Spartan Fire, LLC

Technical Service Bulletin TSB23-520-001A

APPLIES TO: This service bulletin applies to 2021 through 2024 model year, Gladiator, Metro Star, FC-94, KME Panther, and KME Predator emergency response chassis cabs built between April 8, 2022 and March 20, 2023.

CONDITION: 120V box with dual breakers could be wired incorrectly.

Figure 2.1

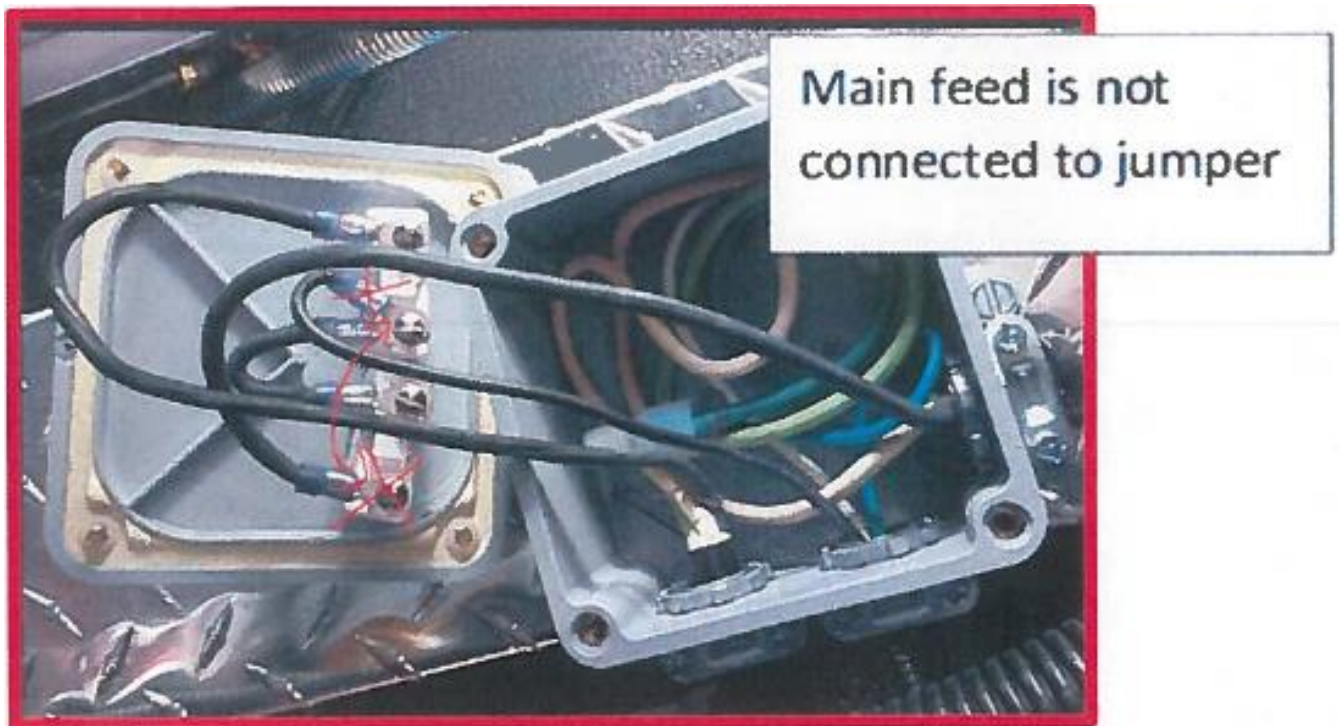
Main Feed Load Line (black wire) coming into box may not be wired correctly to the circuit breakers. If the black wire coming into the box is wired to the outside terminal of the circuit breaker and then the jumper between the circuit breakers is connected to the inner terminals, then the circuit breakers are wired in series, which is incorrect.

See Figure 2.1
